NORTHCREST PEMB DEVELOPMENT
2510 & 2522 CANADA DRIVE
COLORADO SPRINGS, COLORADO
LEISURE CONSTRUCTION

DETENTION BASIN PLAN & PROFILES
PROJECT STATUS: DESIGN DEVELOPMENT

DETENTION BASIN DETAILS 2

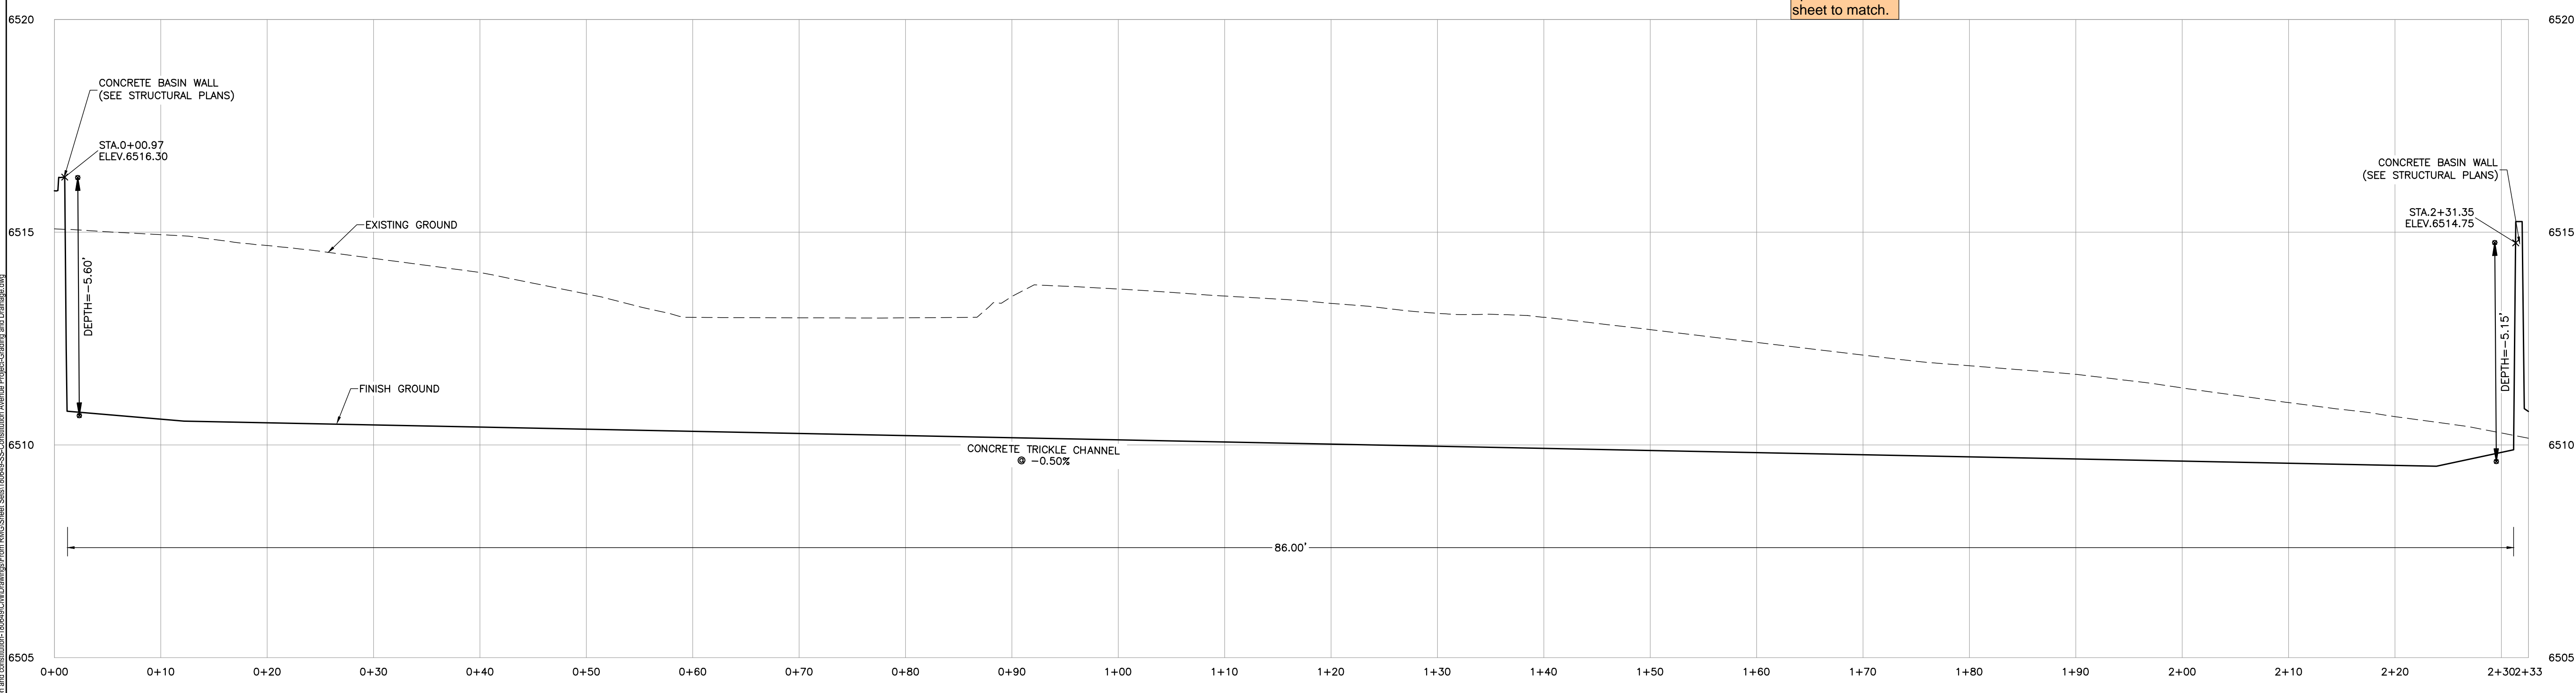
call out pipe diameter since its needed to calculate the forebay and riprap pad dimensions on the following sheet.

They are called forebay 1 and 2 on the next sheet and in the DR. Please update this sheet to match.

since these pond plans and the construction drawings need to be approved, compile all into one document with the GEC which already has signature blocks.

CONCRETE TRICKLE CHANNEL
N.T.S.

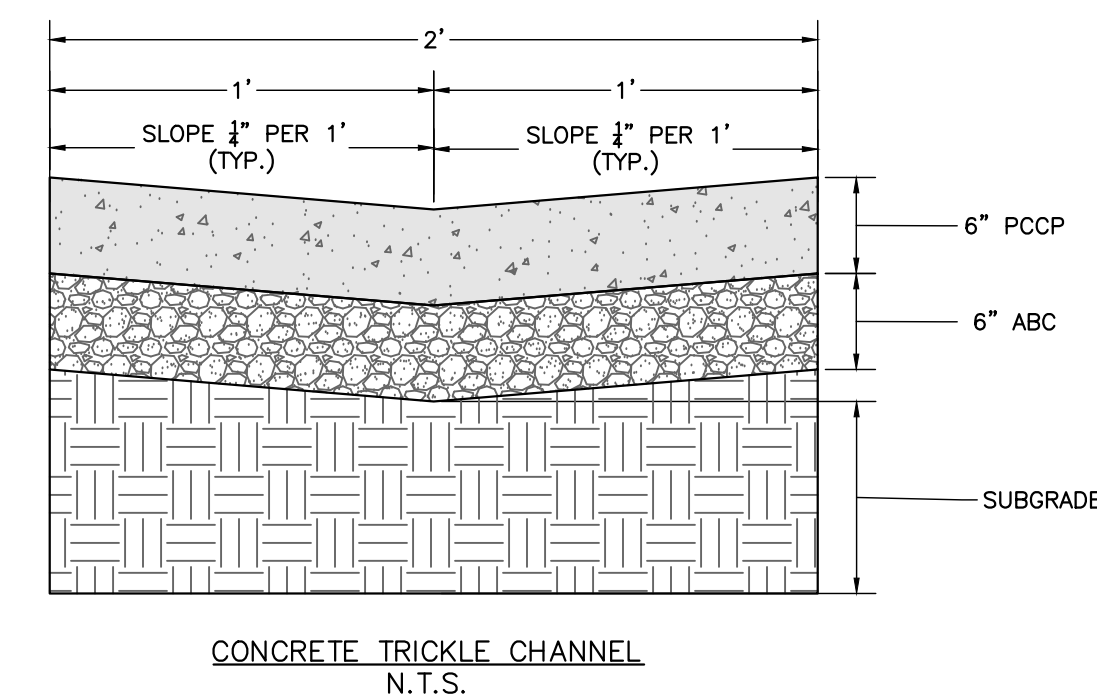
see DR comments

SECTION A-A
N.T.S.

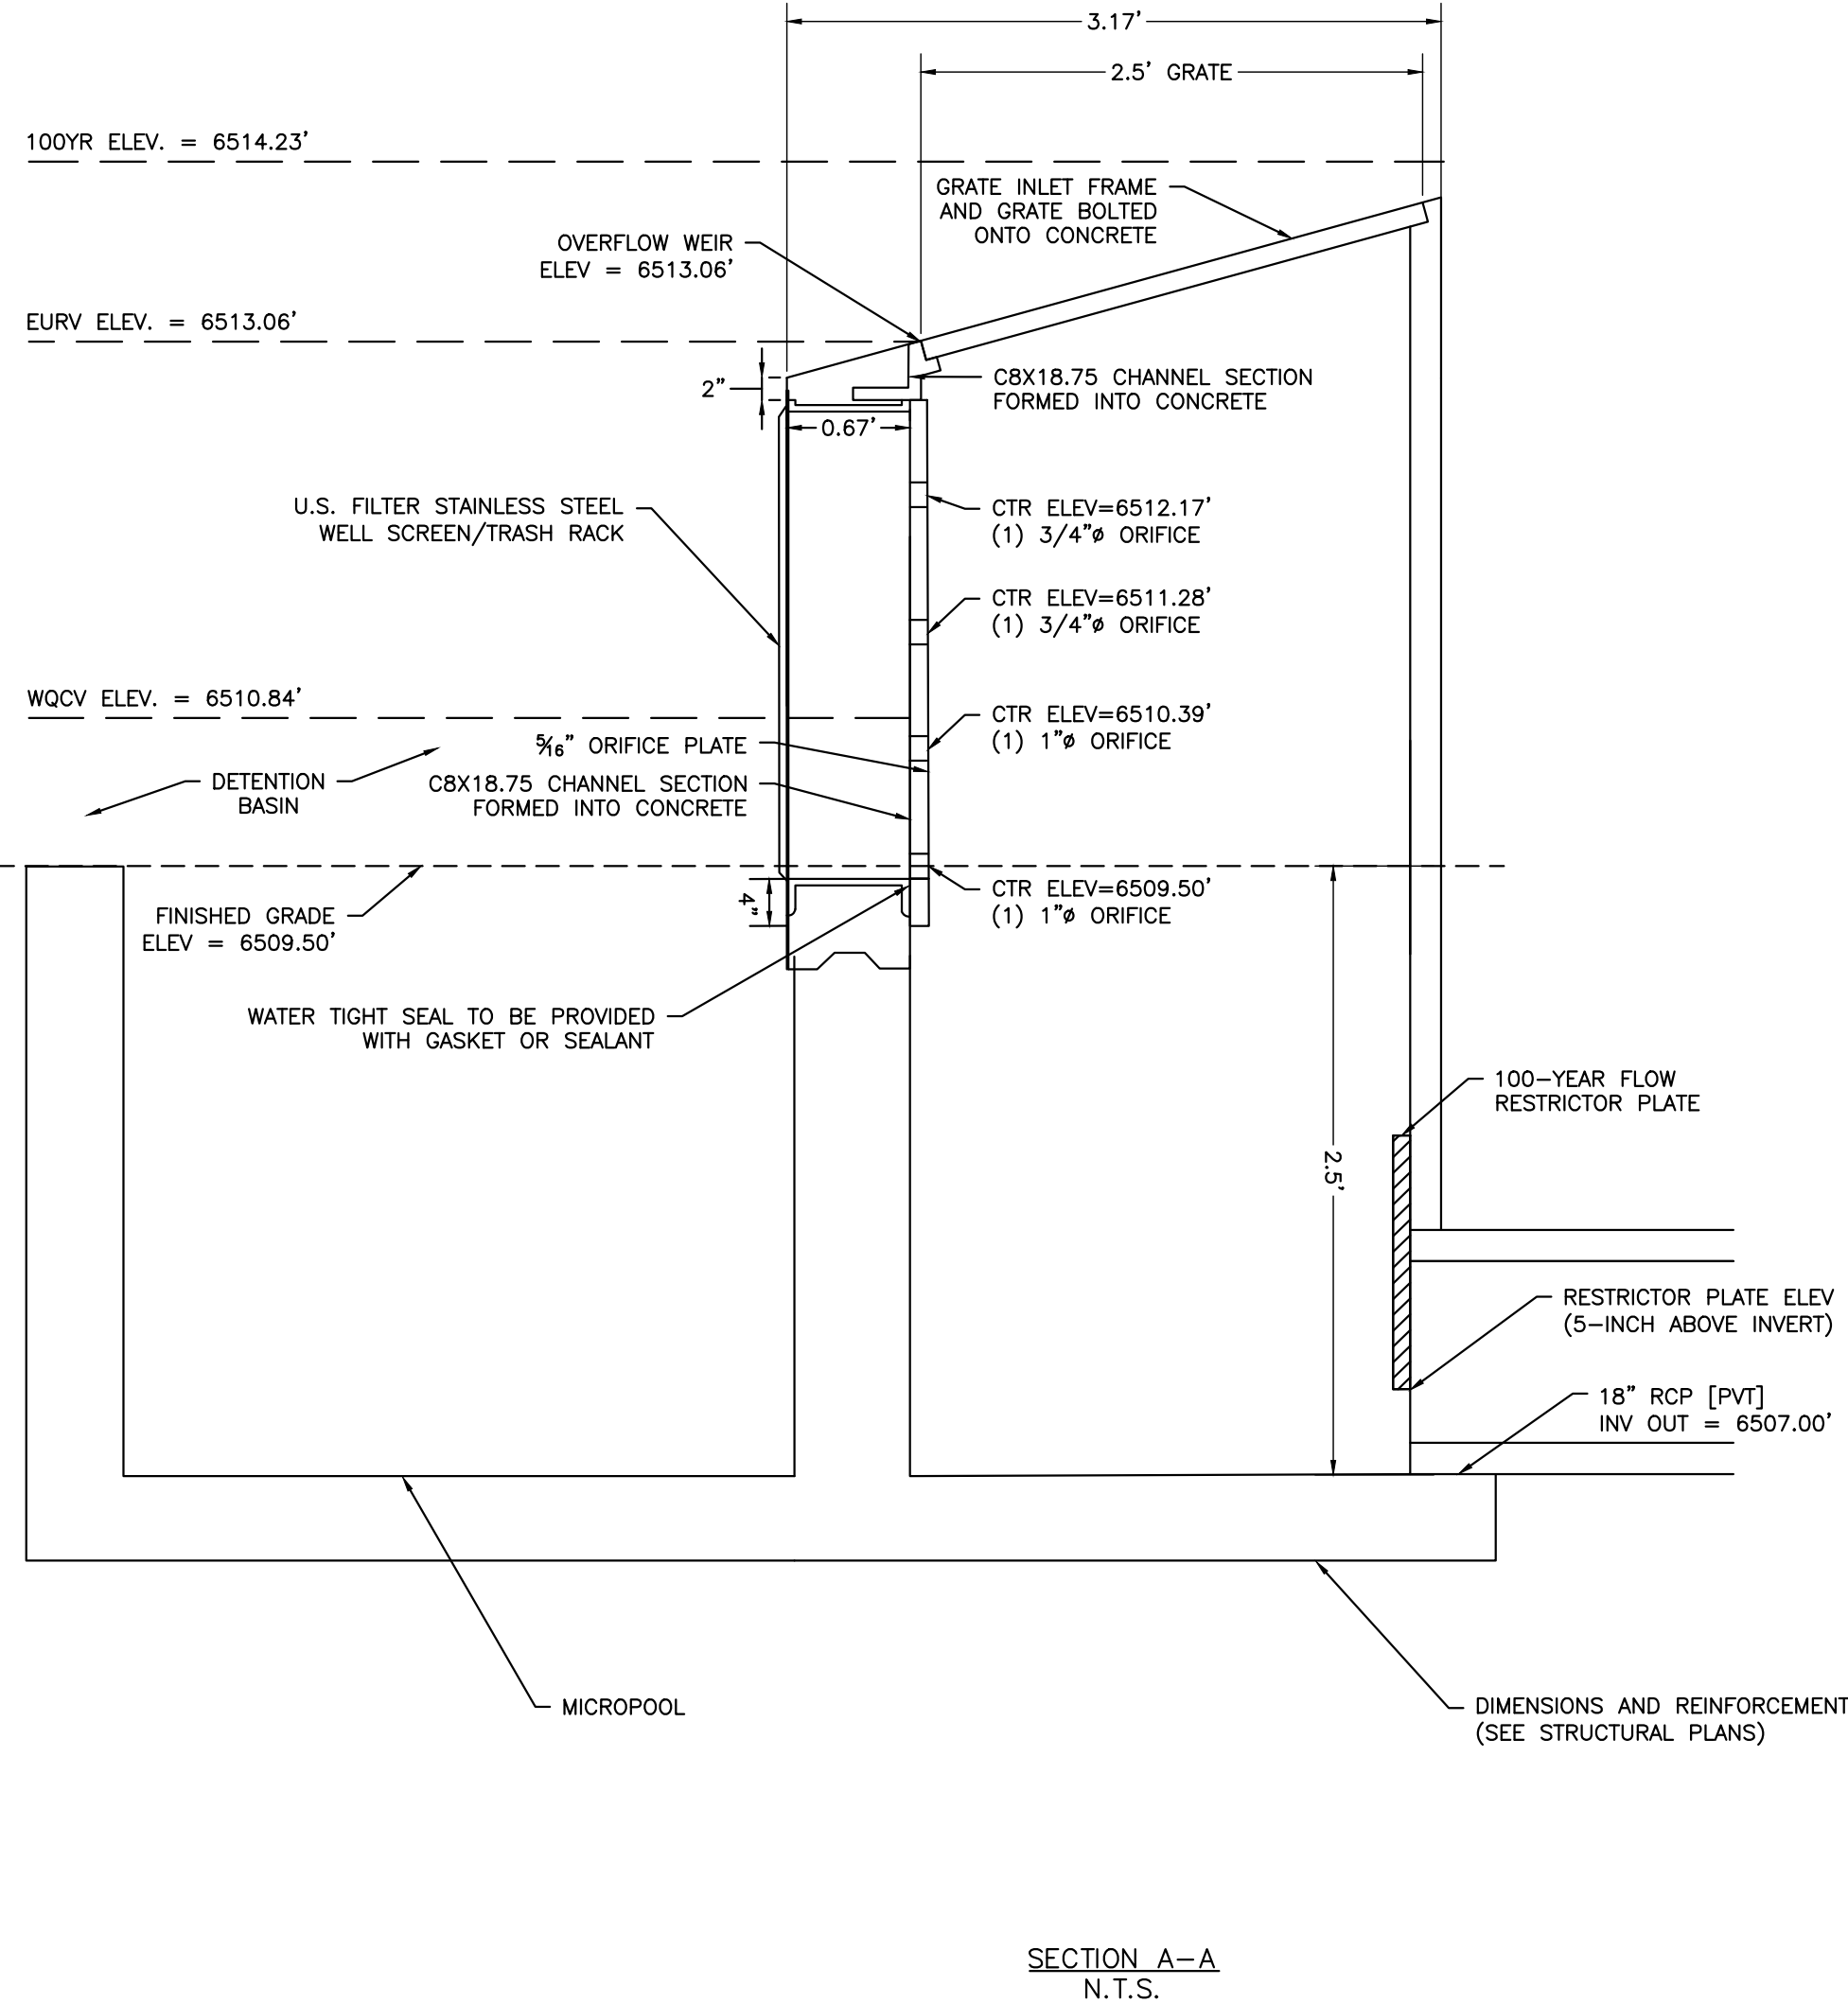
provide details for outlet pipe tie in to existing inlet box and at what elevation
